Re: **Response to KDHE Comments from May 8, 2014 on the 2013 Annual Groundwater Monitoring Report**
MRP Properties Company, LLC – Arkansas City, Kansas
EPA ID No. KSD087418695
VIA FEDERAL EXPRESS TRK#: 7706 1086 2378

2013 Annual Groundwater Monitoring Report

Arkansas City, Kansas

PROPOSED MONITORING WELLS LOCATION MAP

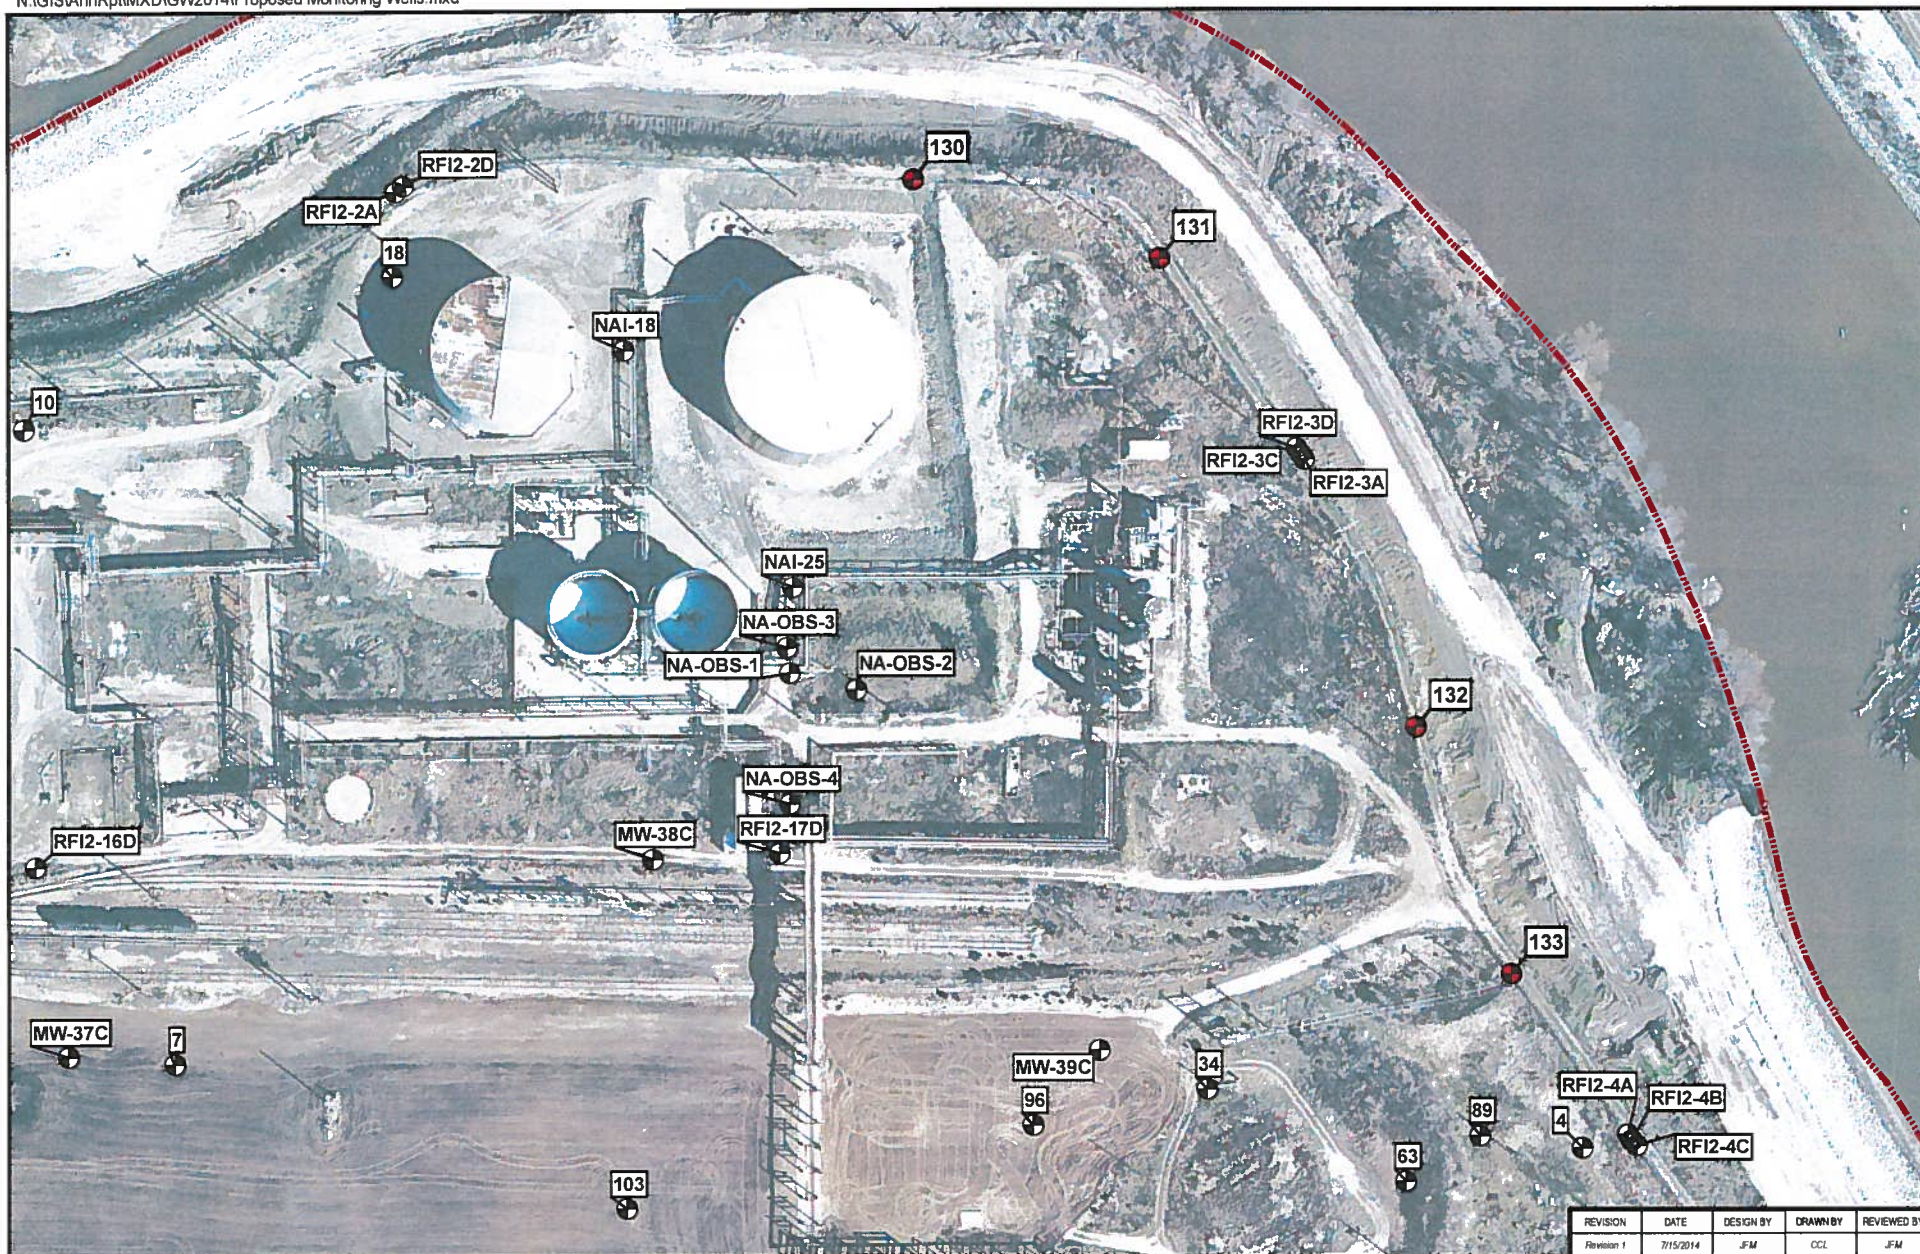
6. *Groundwater containment in the Waste Management Area (WMA) is achieved through pumping of nine groundwater recovery wells to create a reverse groundwater hydraulic gradient between the WMA and the Walnut River. Adequacy of the recovery system for groundwater containment is evaluated by monitoring of reverse groundwater gradients observed at four pairs of strategically placed monitoring wells. Based on the available data, KDHE has a high level of confidence in the current assessment of groundwater containment in the WMA.*

Groundwater containment for areas of the facility outside of the WMA is dependent upon a reverse groundwater hydraulic gradient created by a combination of groundwater pumping at the groundwater recovery wells in the WMA and groundwater pumping at ten product recovery wells in the northern section of the facility. Groundwater pumping rates at the product recovery wells are based on maximization of free product recovery with incidental groundwater recovery. Evaluation of groundwater containment in these areas is based on potentiometric surface contours created from static water level data obtained from interior monitoring wells and a limited number of monitoring wells near the river that are referred to as the Walnut River Boundary wells. To better understand groundwater/surface water relationship in proximity to the refinery site, particularly in the northern part of the facility, KDHE requests MRP to determine river elevation in relation to nearby groundwater elevation at three or four locations on the Walnut River immediately adjacent to the facility boundary. In case there is a need to assess

temporal variations in river elevation in relation to nearby groundwater elevation, it would be important to devise an approach that will ensure reasonable comparability of the individual datasets. This information should supplement data from the upstream USGS river gauge at Arkansas City to determine whether the river is gaining or losing over time. These elevations can be used to better assess any reverse gradients between the aquifer and the river and increase the level of confidence in the adequacy of groundwater containment for groundwater north of the WMA. Depending on the results of this assessment, it may also be beneficial to consider installation of additional monitoring wells or piezometers at optimized locations.

Pursuant to the conference call held between MRP, MWH, and KDHE on June 12, 2014, MRP will install four monitor wells along the boundary with the Walnut River. Two of the monitor wells will be installed between the RFI2-2A/C/D well cluster and the RFI2-3A/C/D well cluster and two monitor wells will be installed between the RFI2-3A/C/D well cluster and the RFI2-4A/B/C well cluster. The planned monitor well locations are shown on the attached location map.

The purpose of these four monitor wells is to provide additional definition of the groundwater potentiometric surface at the north east portion of the site to aid in assessing the groundwater gradient and flow direction in the vicinity of the Walnut River. The monitor wells will be installed according to the procedures described in Section 3.1 of Addendum No. 1 to the RCRA Permit Renewal Appendix P Groundwater Sampling and Analysis Plan. As an alternative to the investigation derived waste procedure described in Section 3.1.3, MRP may characterize the soil according to the special waste disposal facility testing requirements for offsite disposal.
